Our Ref: 21-367
Your Ref: DA2021/53

Addendum: Erection of a 4.95MW Solar Farm, 2910 Gwydir Highway Moree NSW 2400

This addendum provides additional information to the Moree Plains Shire Council to clarify matters outlined in the request for additional information received on the 17th of December 2021. This document should be assessed in conjunction with the Statement of Environmental Effects (SEE) prepared by SMK Consultants (September 2021) in support of the proposed construction of the Wathagar Solar Farm.

Figure 4: Angle of the sun above the horizon for both the summer and winter solstice.

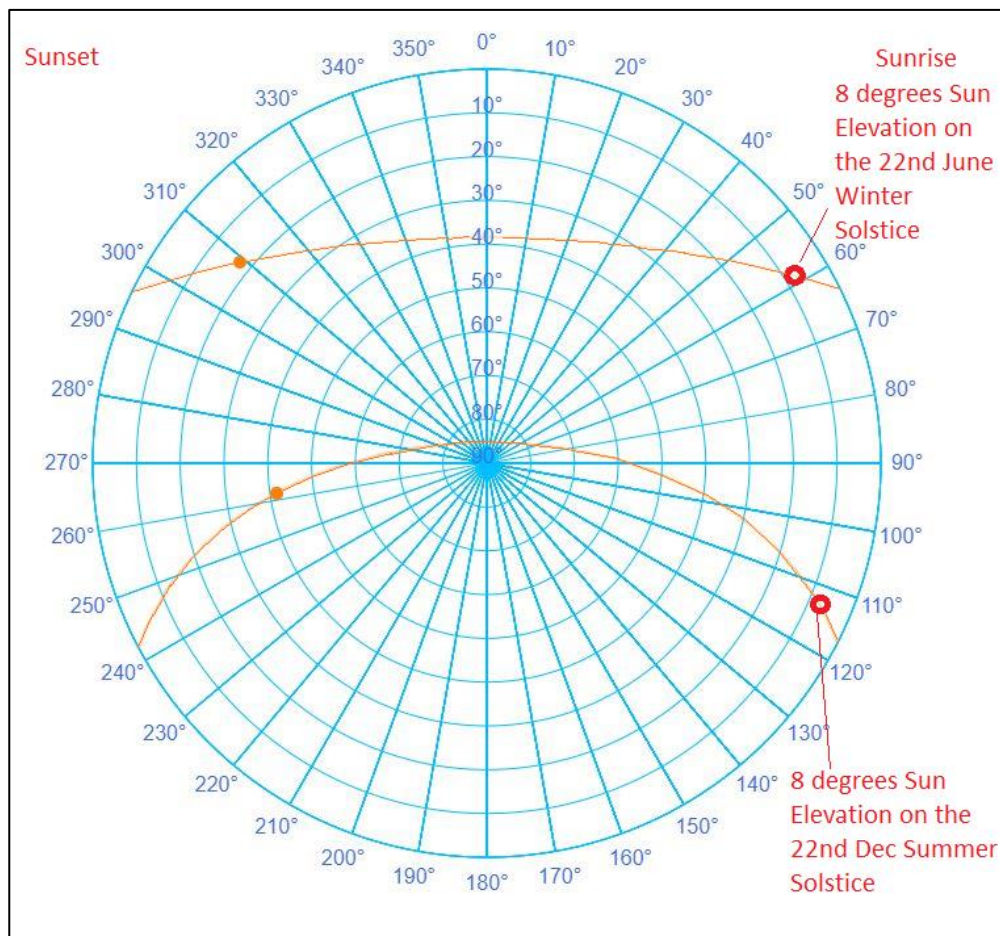
In relation to Council's raising possible concern surrounding potential glare/glint impact to drivers, as explained above the angle of incidence to the sun creates the glint and glare.

The diagram included as Figure 4 below shows the angle of the sun above the horizon for both the summer and winter solstice.

During the summer solstice the sun is south of the solar panels and any glare or glint would be directed to the north away from the Gwydir Highway, causing no effect to passing traffic.

During the summer solstice the direction the glint and glare would be at a maximum around sunrise. The solar panels are fixed at alternating 8 degrees to the west and 8 degrees to the east. Because the panel is angled towards the west by 8 degrees this early morning glint at say 10 deg would be angled downwards at 6 degrees, the glint would hit the adjacent panel and have no effect on passing traffic. At this elevation the glint would be angled in a north westerly direction away from the road which is to the south of the panels.

Examining the winter solstice, the direction of glint and glare will be in a southerly direction. The minimum angle to create glint is about 5 degrees of sun elevation where the winter sunrise is slightly angled across the solar panels.

Figure 5: Reflection of sun's rays from solar panels at minimum angle of 5 degrees

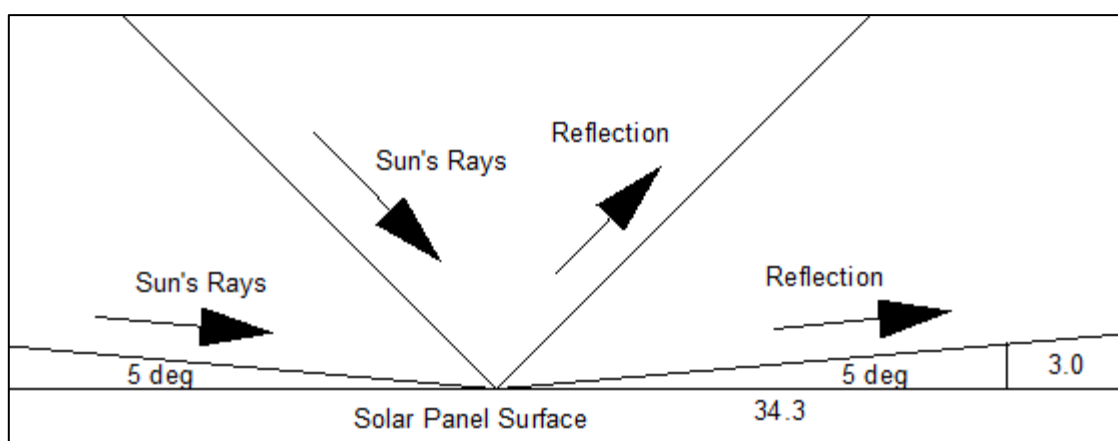
The maximum height above road level for a car driver is 1.2m and a truck driver 3m, as shown in Table 1.

Reflection from the solar panel surface at the minimum angle of 5 degrees will be above the eye level of a truck driver at a distance from the edge of solar array of 34.3m. The Gwydir Highway is about 85m away, therefore no effect on passing traffic will occur.

At all other times of the day the reflected light will be more vertical and the 34.3m distance would be less, therefore no effect on traffic.

Figure 6: Lidar Data showing elevations along the eastern side of the proposal solar farm

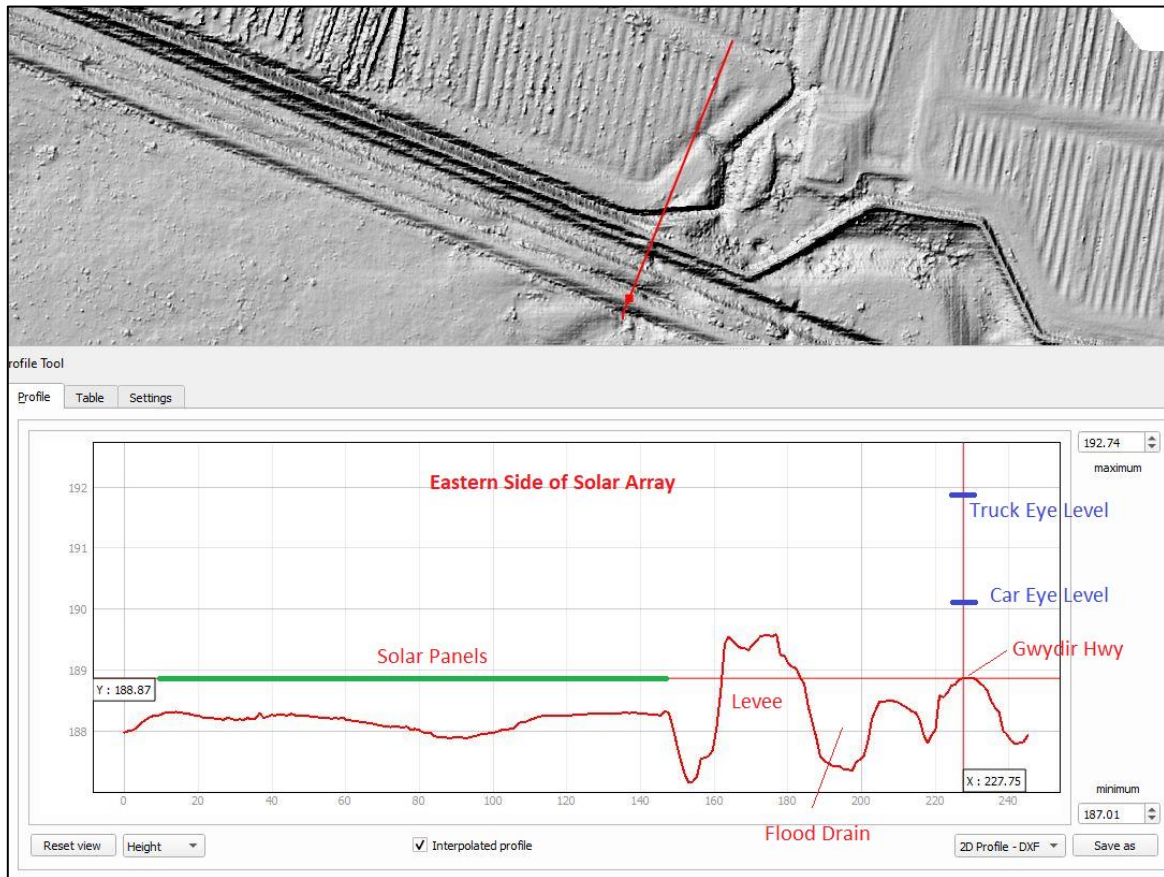
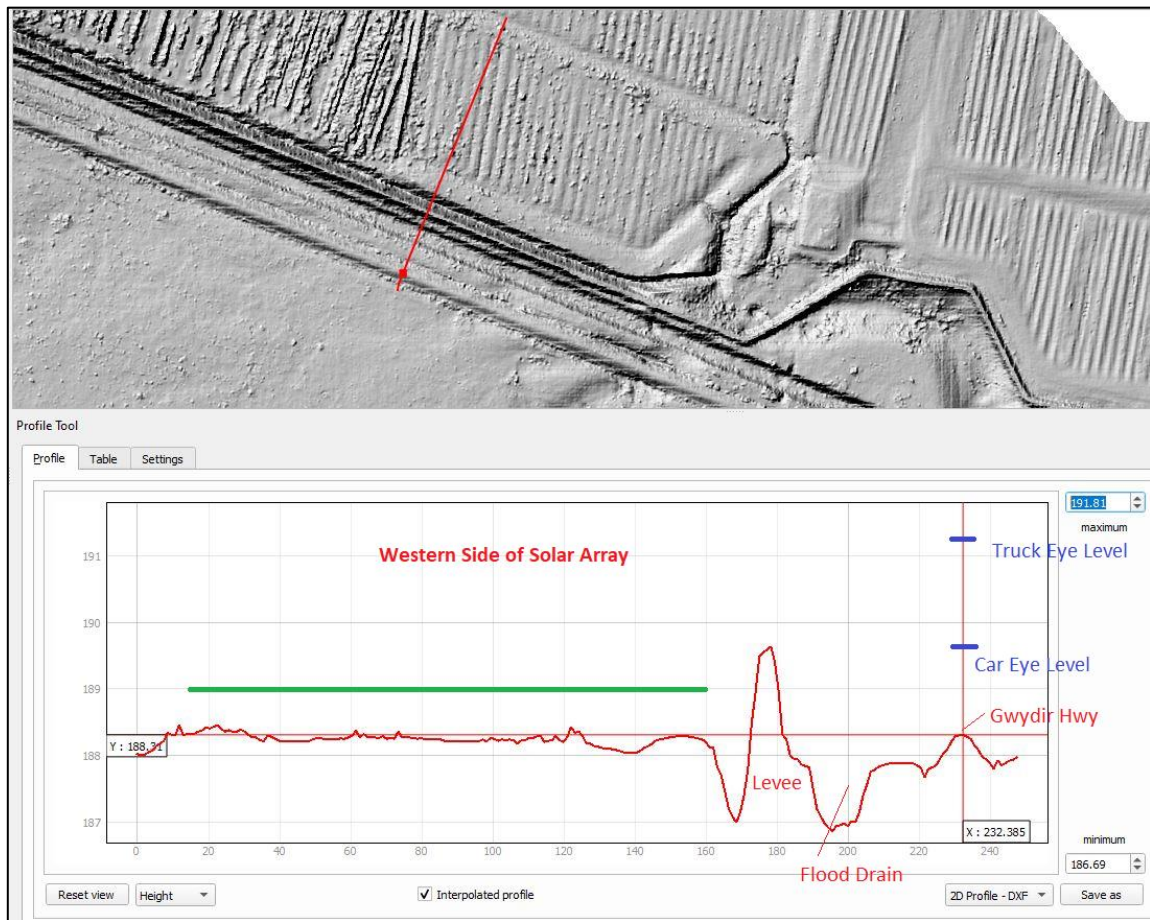
Council has requested that mitigation measures be identified to reduce visual impact on rural landscaping in accordance with the objectives of the RU1 zone.

As shown in Figures 6 and 7 below, the eye of a car driver is slightly above the levee bank height at the eastern end of the solar array which allows half of the panels to be visible for motorists travelling in cars. To a truck driver most of the panels are visible. At the western end of the solar array a car cannot see the solar panels, but a truck can see most of the panels.

As illustrated in Figure 8 above, the proposed solar panels would have minimal impact on the visual aspect of the site. The panels are partly hidden to all car traffic on the Gwydir Highway and the side profile to trucks is minimal compared to the existing buildings associated with the cotton gin on the site. The cotton gin building and seed shed are significant when compared to the minor visual profile of the panels. The profile of the panels is below the horizon and their profile are of a similar colour to the remainder of the gin yard. We believe the solar panel array's visual aspect is minor and should be acceptable. No additional mitigation measures are therefore considered to be required, as the existing levee, which can be considered an existing mitigation measure, would obscure all (for motorists in cars) or the majority (for truck drivers) of the proposed development from public view.

Further, the glare and glint will not impact passing traffic as all reflected glare or glint is above the height of all vehicles traversing the highway.

Project: Wathagar Gin
Title: Site Layout

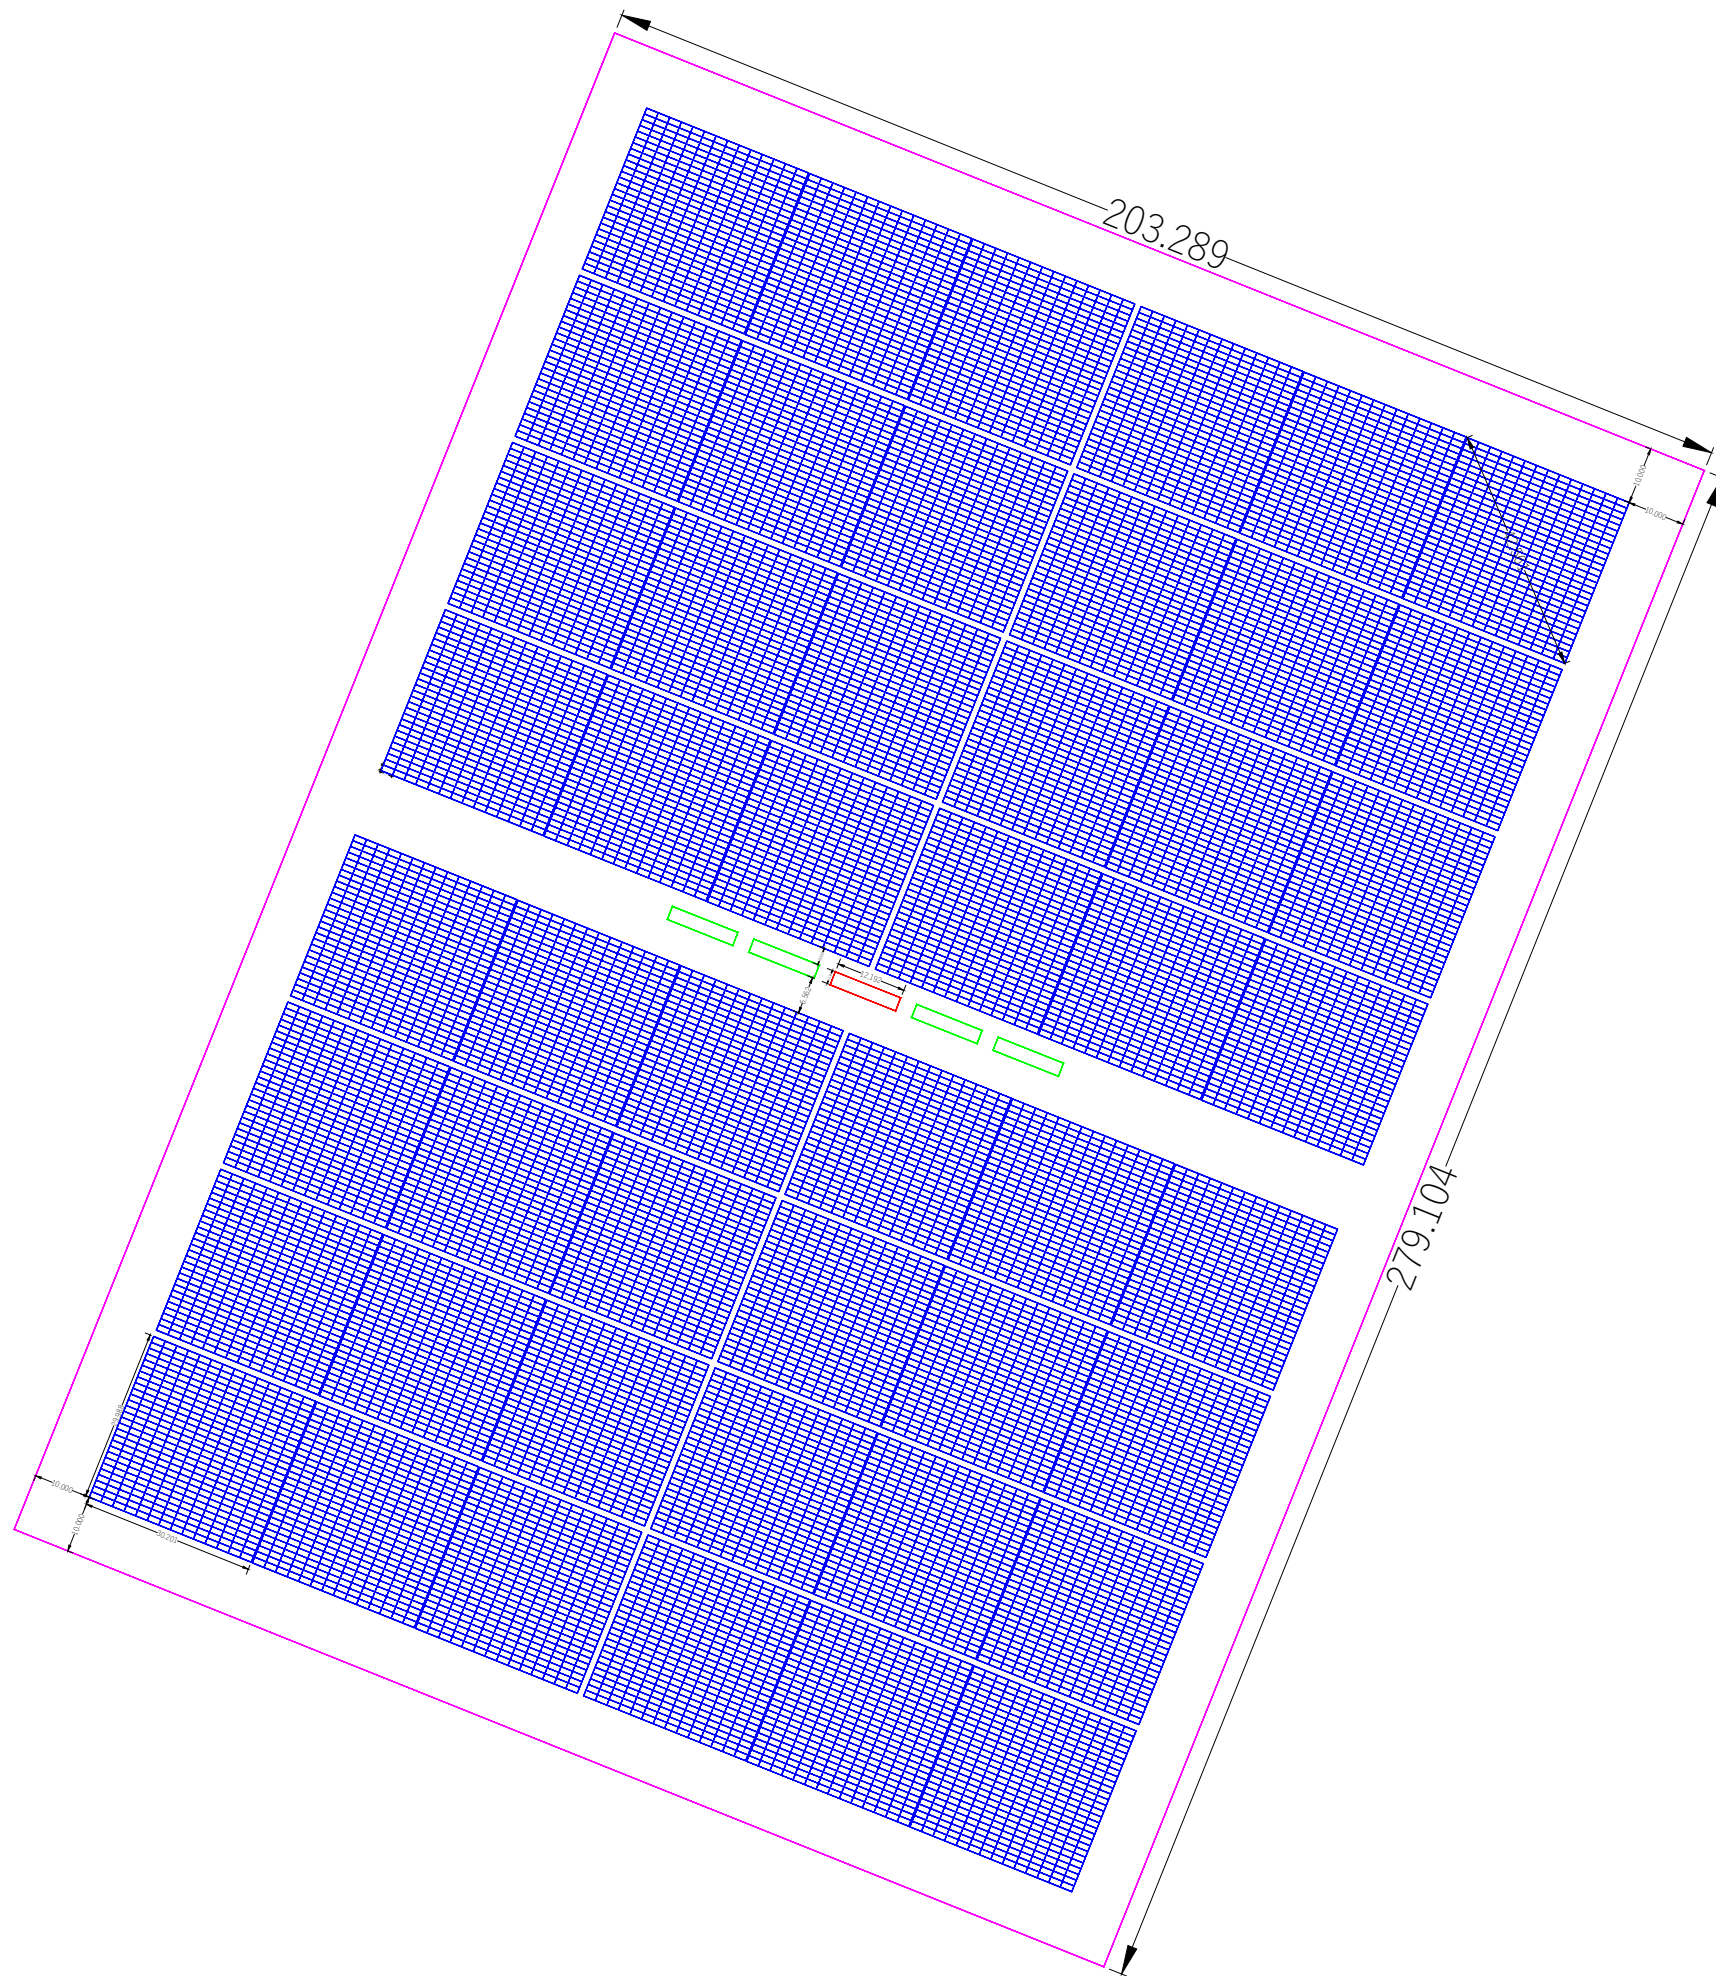
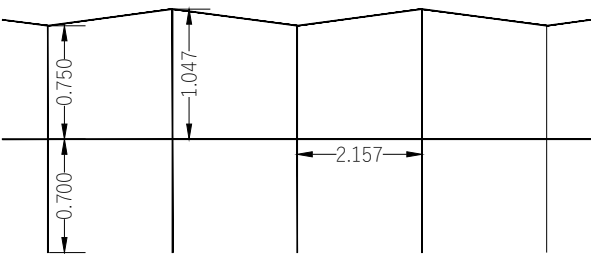
- Elevations of PV Panels maximum height of solar panels at full tilt – shown in the site plans in Appendix 2. The elevations are shown on the right-hand side of the plans and are labelled 'Front View'.
- Elevations of inverter stations and battery storage – included in the design plans in Appendices 3 (Battery) and 4 (Inverter).

- Offset from boundaries and Gwydir Highway – Included in Appendix 2.
- Stormwater management plan – Included as Appendix 5.
